Additional repairs resulting from the field inspection on 03/24/2014.

FRAMING PLAN - SUSPENSION SPANS 1 OF 6
BRIDGE NO. LUC - 2 - 1862
STATE ROUTE 2 OVER MAUMEE RIVER

LUC-2-18-62
PID No. 80551

REPAIR TYPE 216
(FILL PLATE DETAIL)

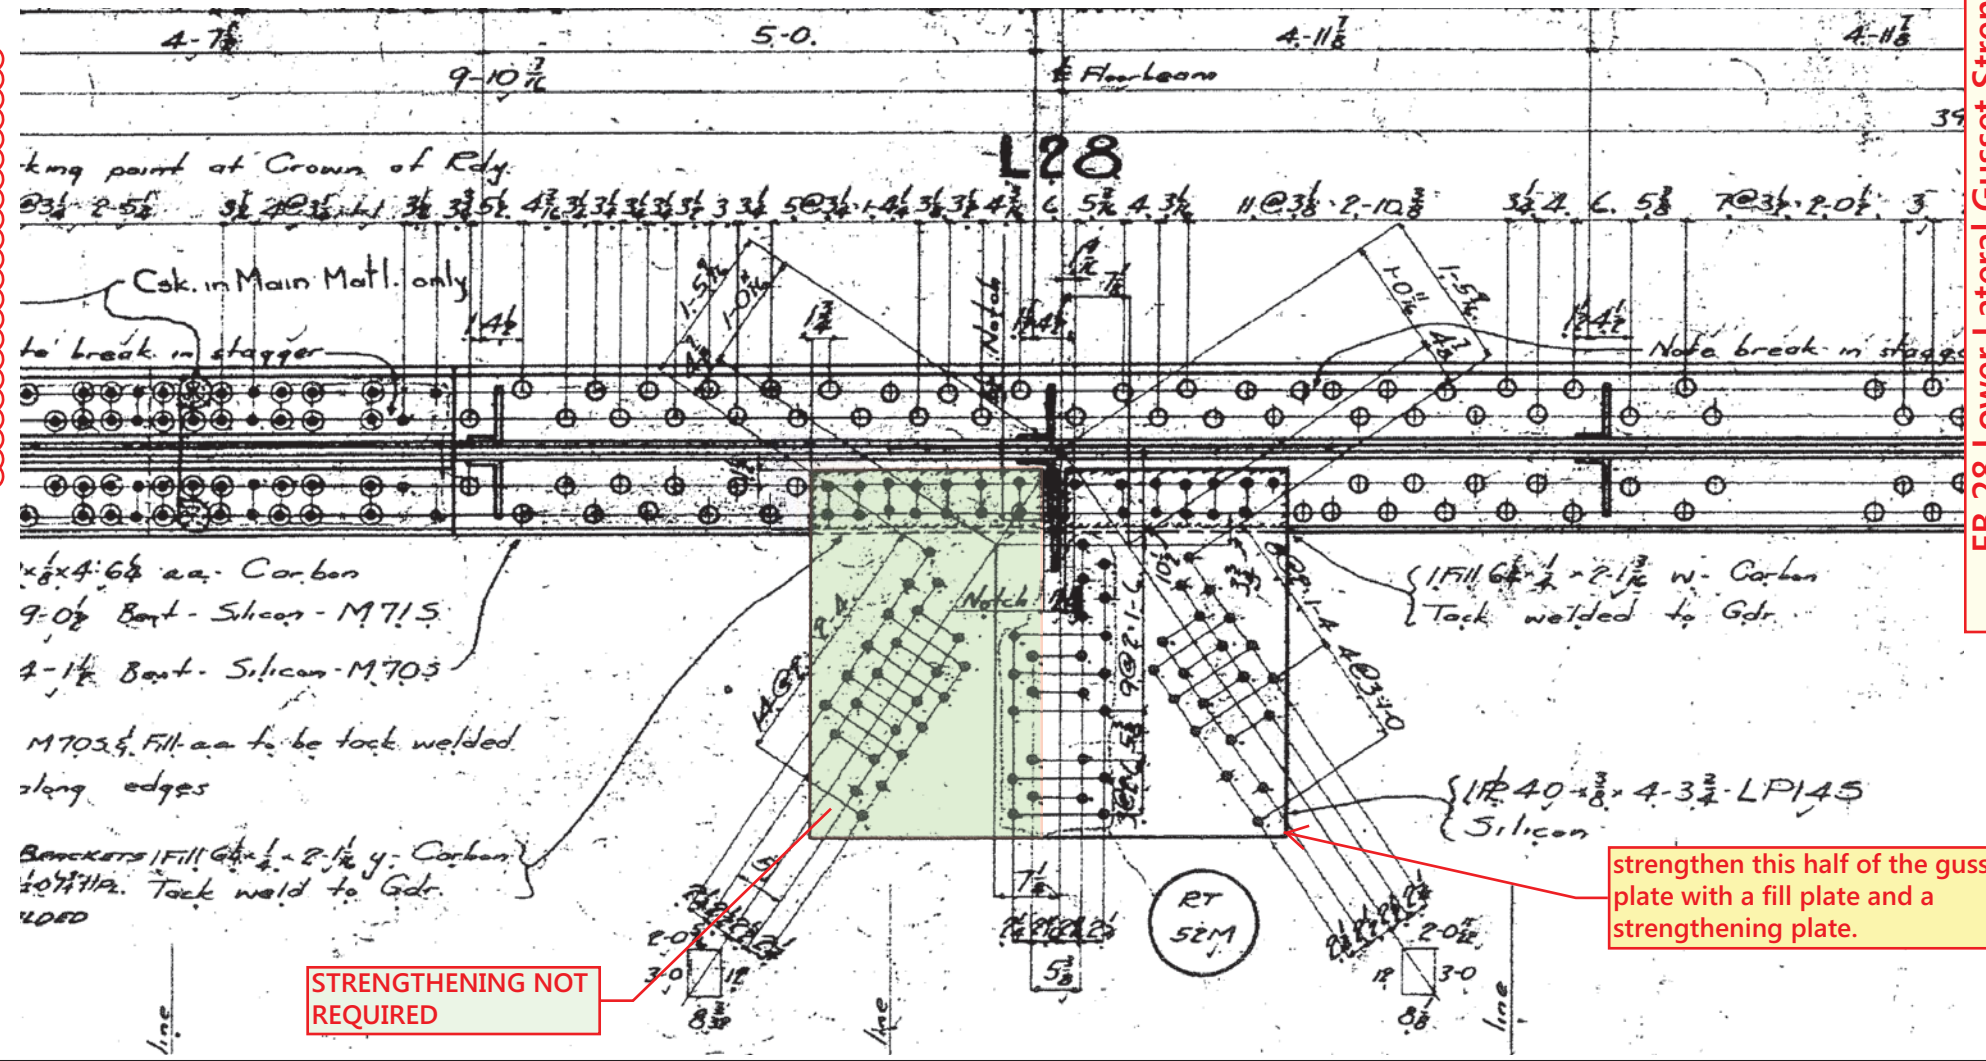
Dimensions to be shop-modified to match existing L28 details below

REPAIR TYPE 309A

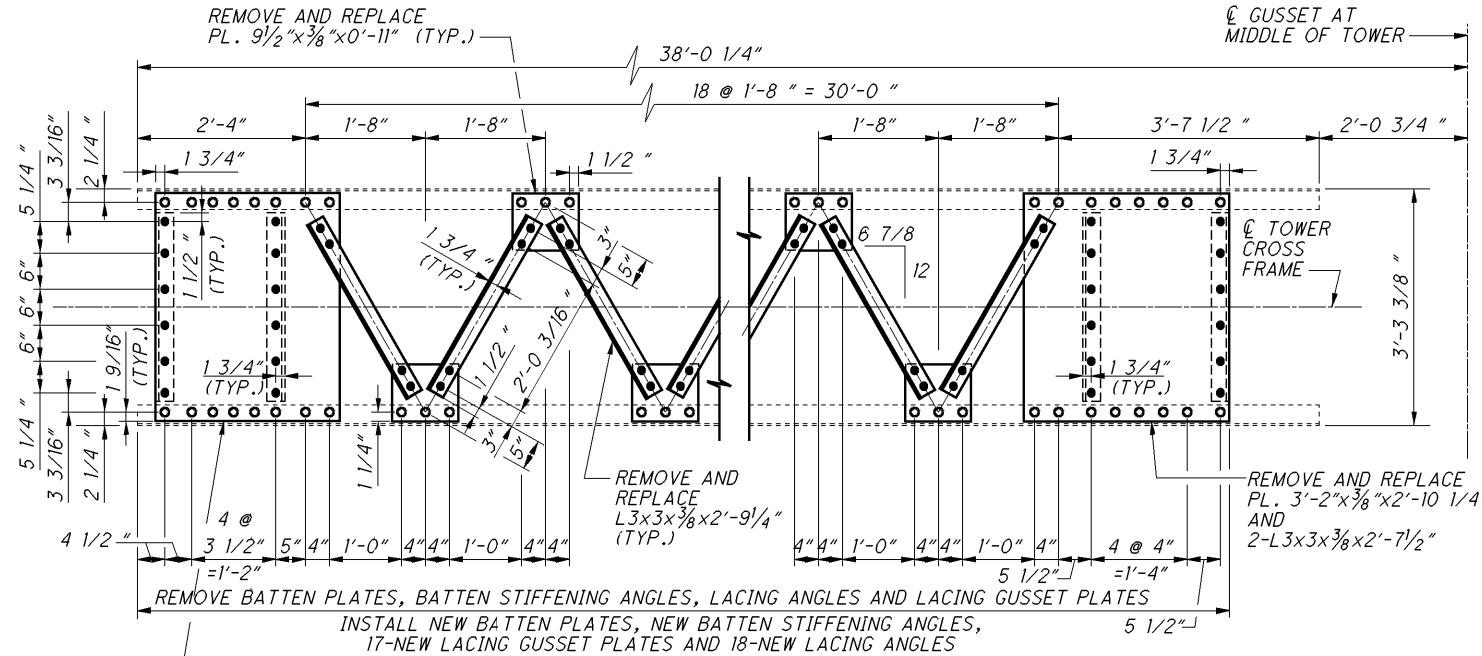
REMOVE BATTEN PLATES, BATTEN STIFFENING ANGLES, LACING ANGLES AND LACING GUSSET PLATES
INSTALL 2-NEW BATTEN PLATES, 4-NEW BATTEN STIFFENING ANGLES, 41-NEW LACING GUSSET PLATES AND 42-NEW LACING ANGLES
ADD. 6
